ADCO ITP Documentation

LGF Pour 1a

Contents

DRAWING TITLE
STRUCTURAL DRAWING
LOWER GROUND FLOOR
SLAB PLAN - GRID C-I

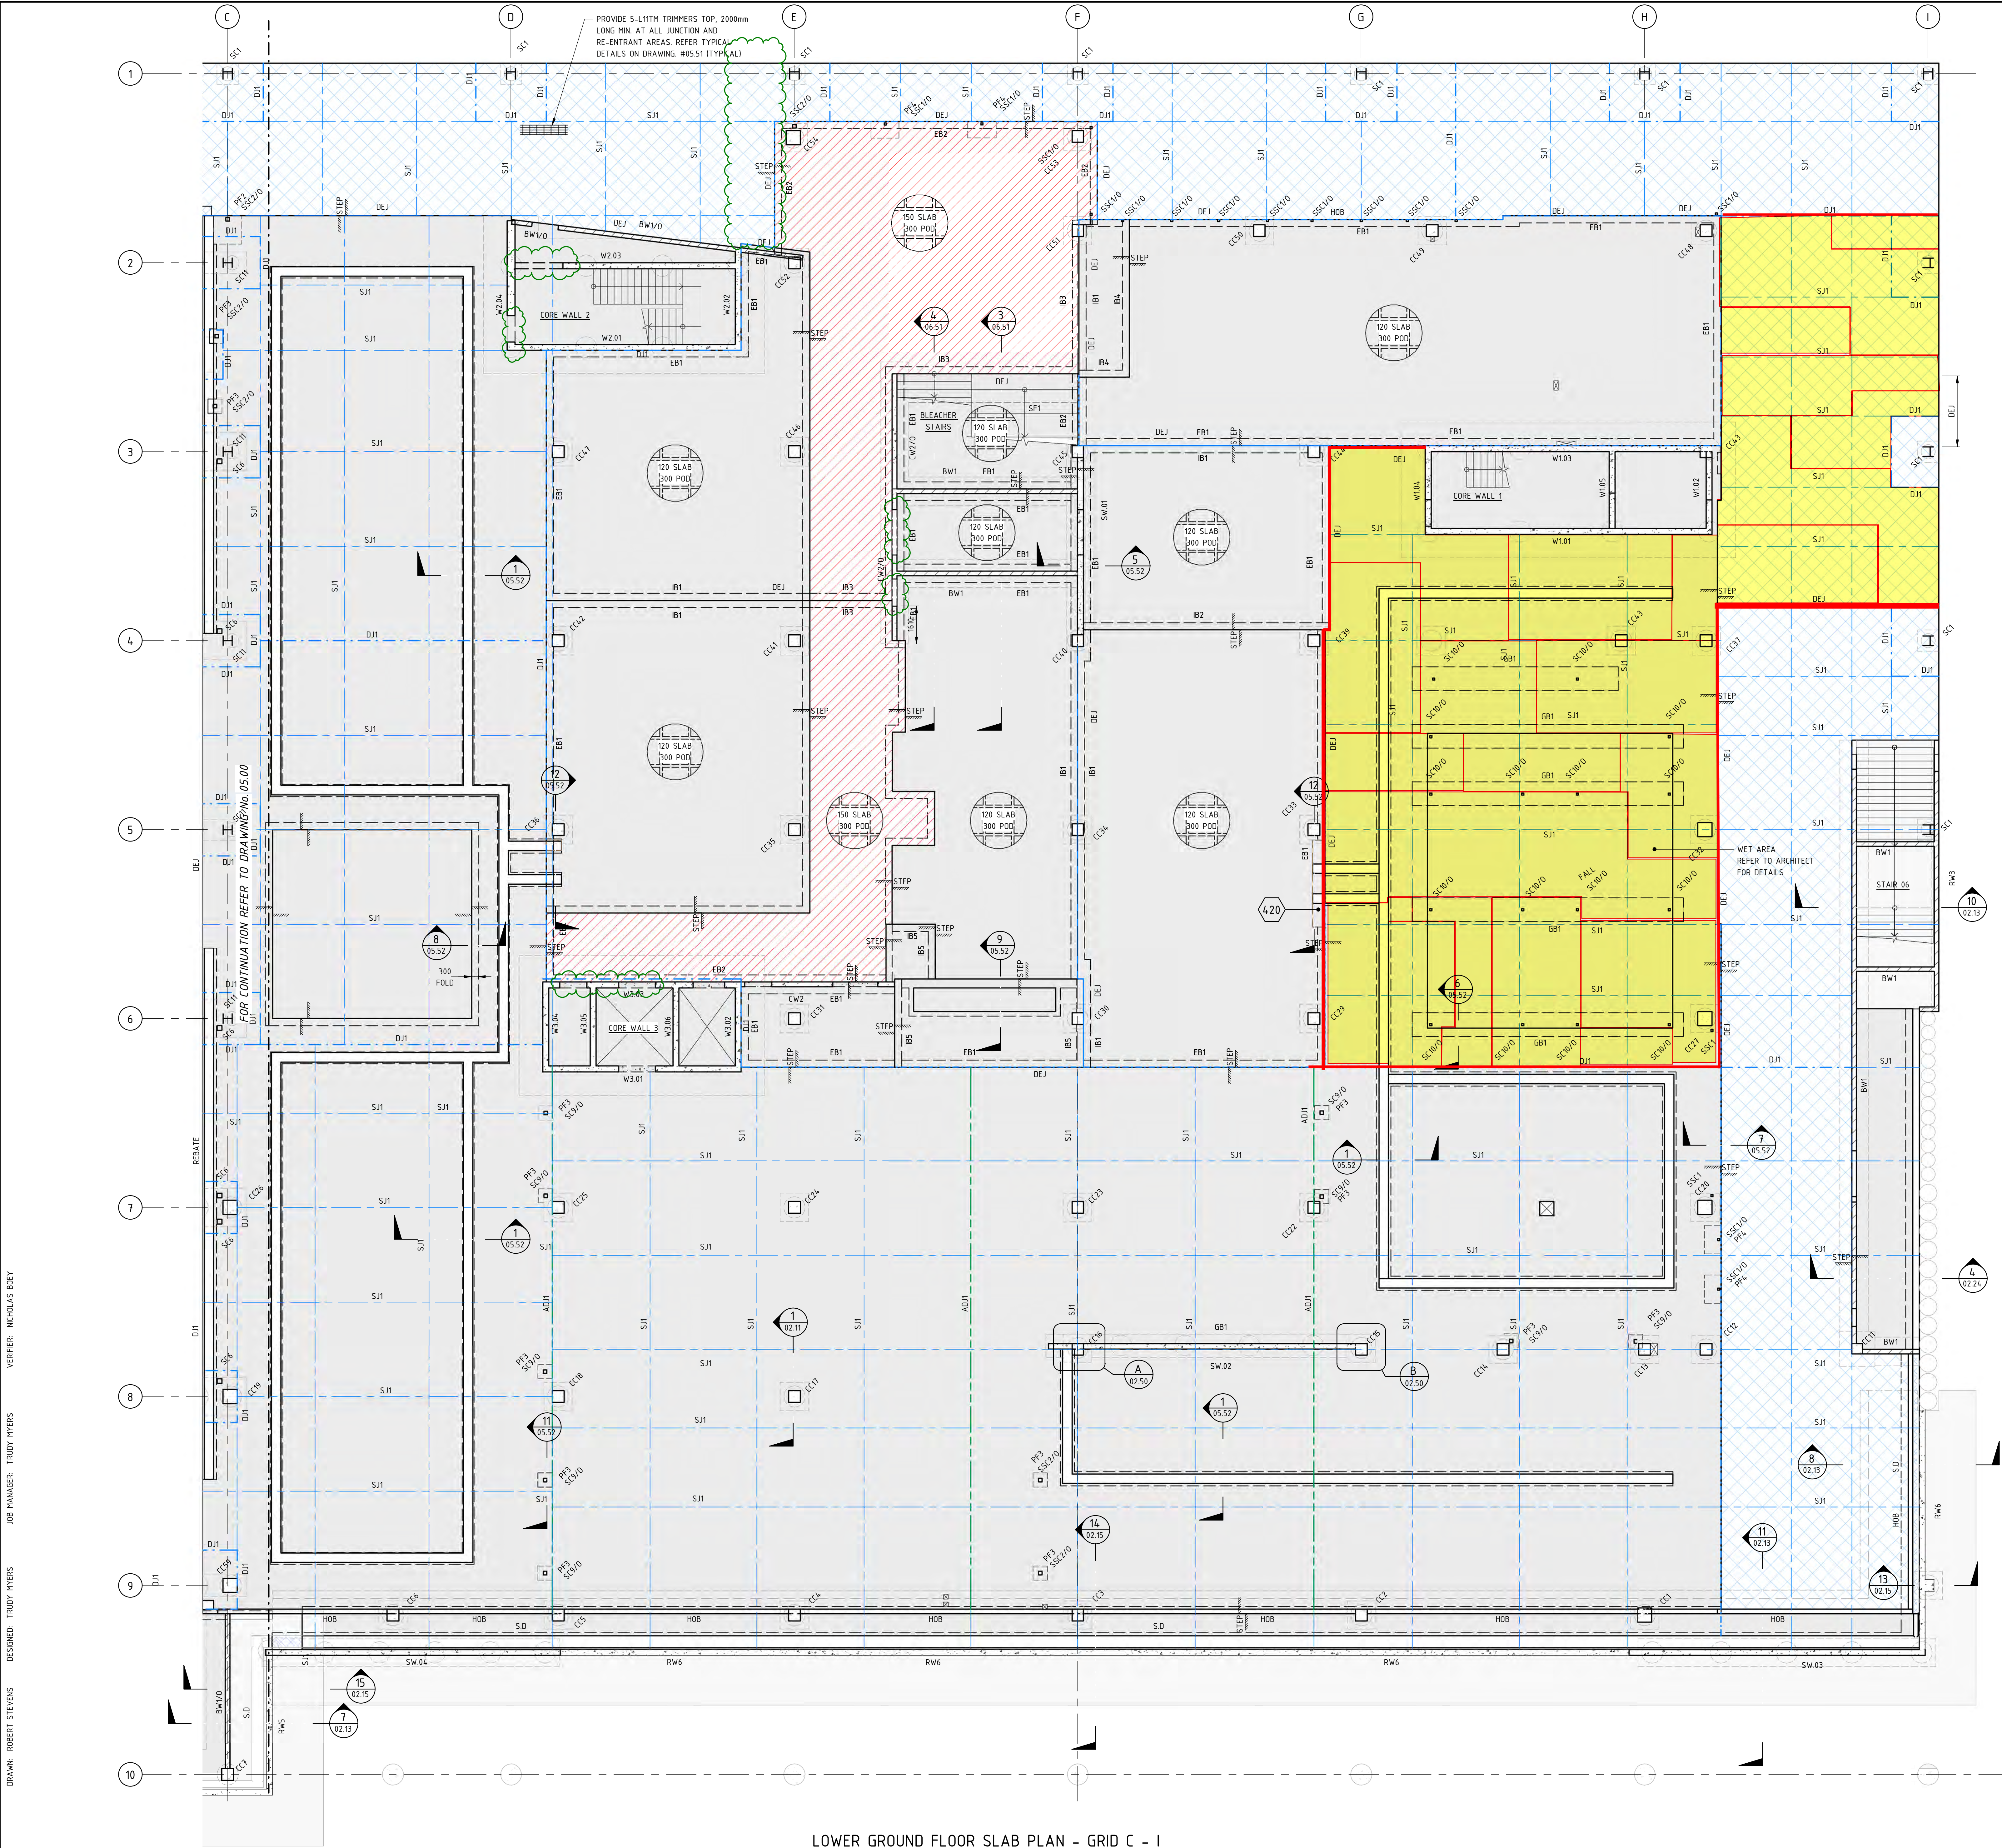
5. North DEJ dowels appear set too high. Dowels should be positioned at midheight of lower external base slab as per Section 7 drawing 05.52.
6. Install thickening reo (L bars and longitudinal bars) to slab edge as per Section 7 drawing 05.52 (North DEJ)

7. Ensure all dowel sleeves are installed horizontally and at correct spacing. Eastern joint dowel sleeves do not appear flat and spaced too far apart. Dowel type and spacing should conform to our dowel schedule or another approved equivalent. Please confirm size and spacing of these dowels.

LOWER GROUND FLOOR SLAB-CONCRETE POUR AREAS

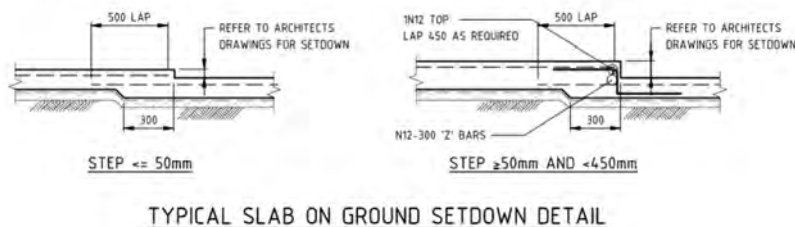
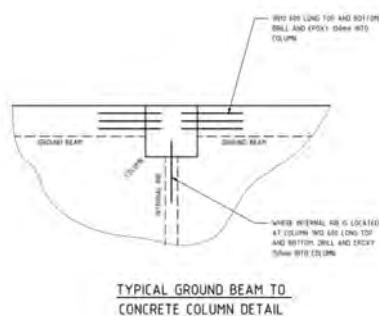
1. Trimmer bars around penetrations and floor boxes
2. At some setdowns, the mesh did not have adequate lap. Lap at setdowns at shown below:

3. At the locations where the IB1 beams are discontinuous, use the details below. This is in lieu of local widening since you have no spare trench mesh and ties. Refer to NE-ST-DWG-C0-05.53.

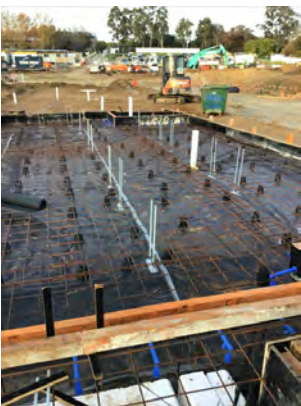
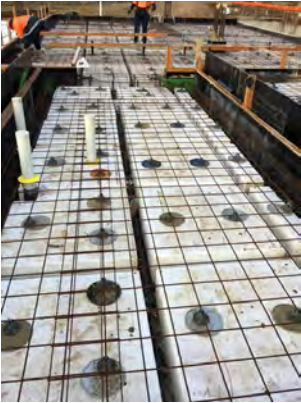
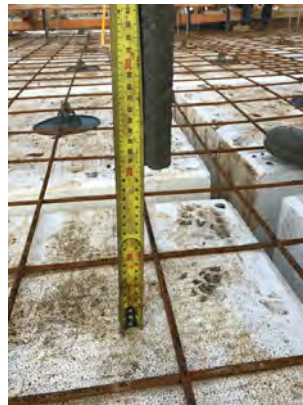
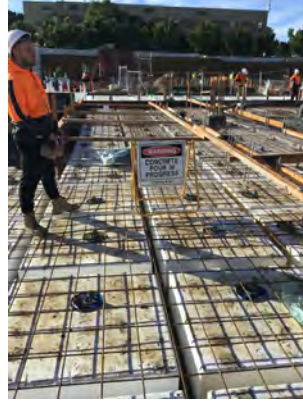
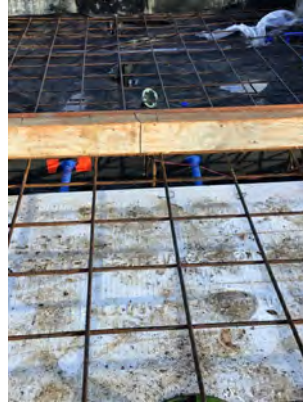
Rebate is touching the steel no cover Formwork is still working on stepdown's Formwork- No bracing Slab overexcavated by 100mm No cover in the rebate

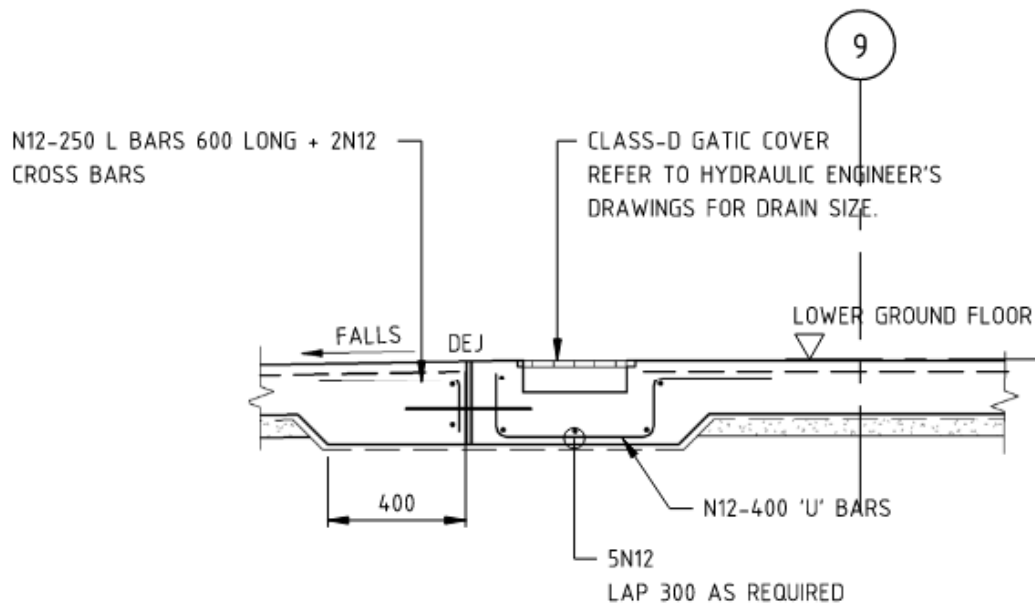
- 2) Cannot see photos of the pad footings PF3 shown below. Ensure these are placed.

3) The trench shown in section 2 above is not formed. Ensure this is rectified prior to pouring.

Item 2 and 3 are very important to rectify ASAP prior to pour.

LOWER GROUND FLOOR SLAB PLAN - GRID A - C

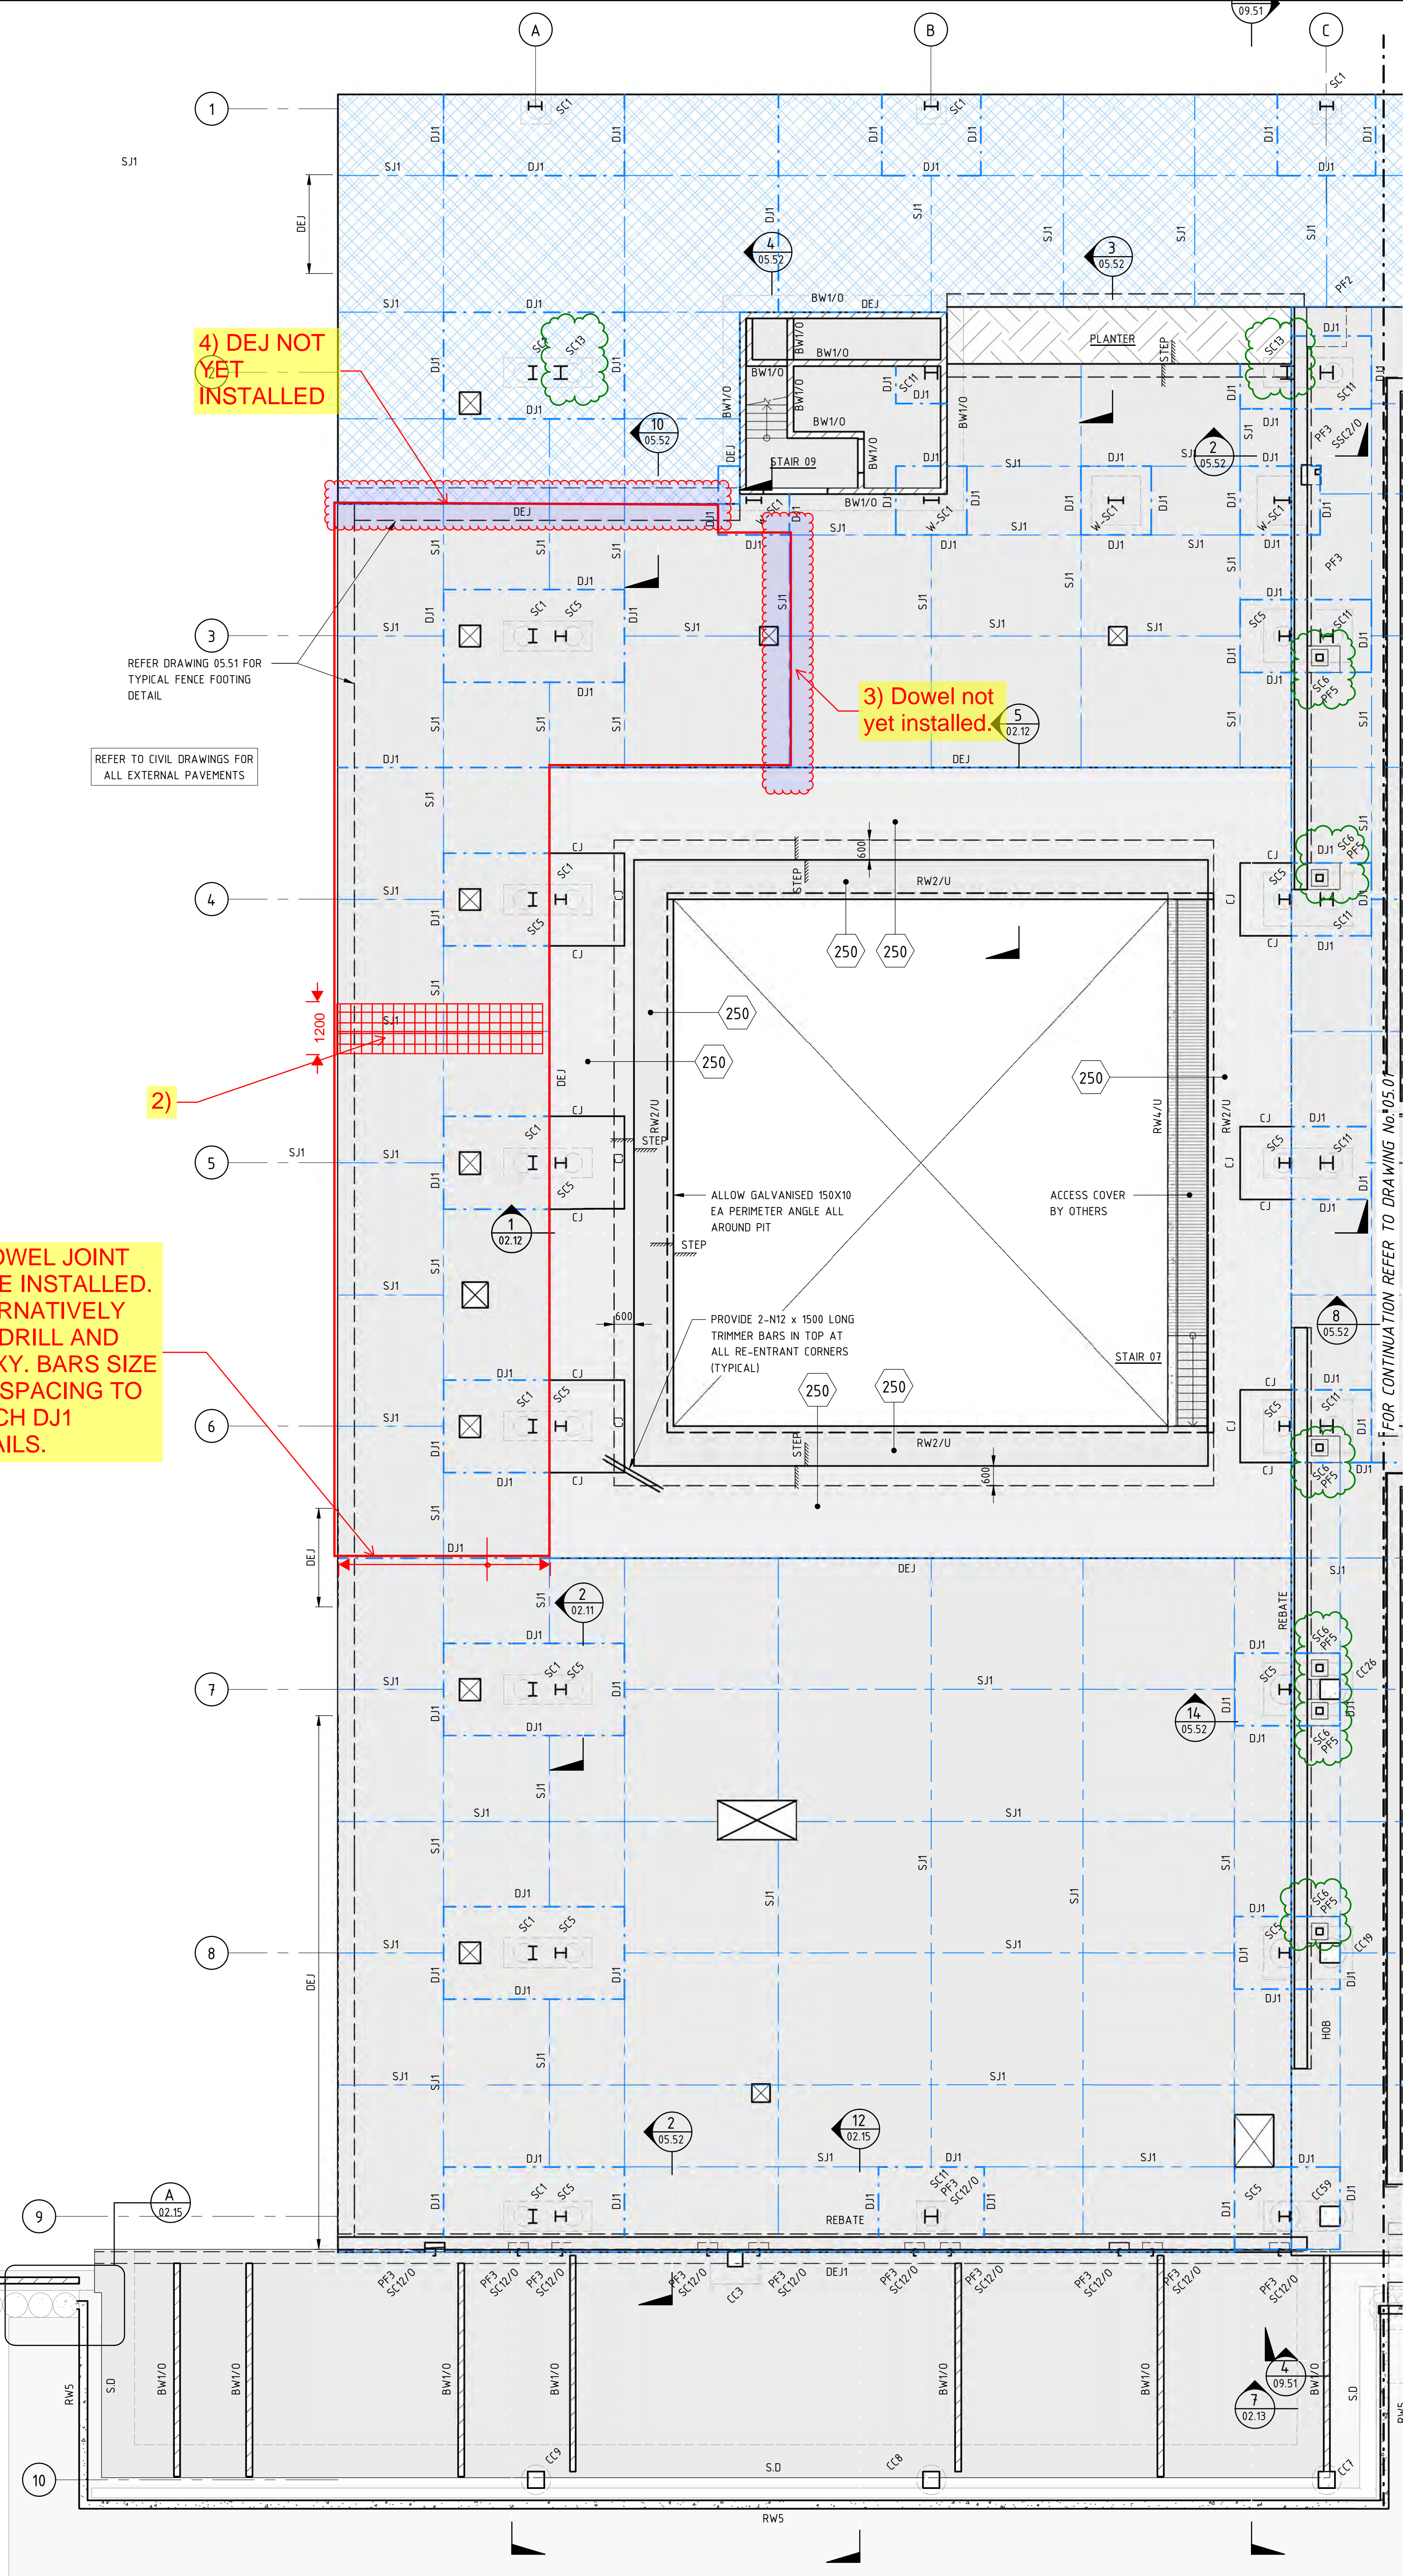
5) DOWEL JOINT TO BE INSTALLED. INTERNATIVELY USE DRILL AND EPOXY. BARS SIZE AND SPACING TO MATCH DJ1 DETAILS.

4) DEJ NOT YET INSTALLED

3) Dowel not yet installed.
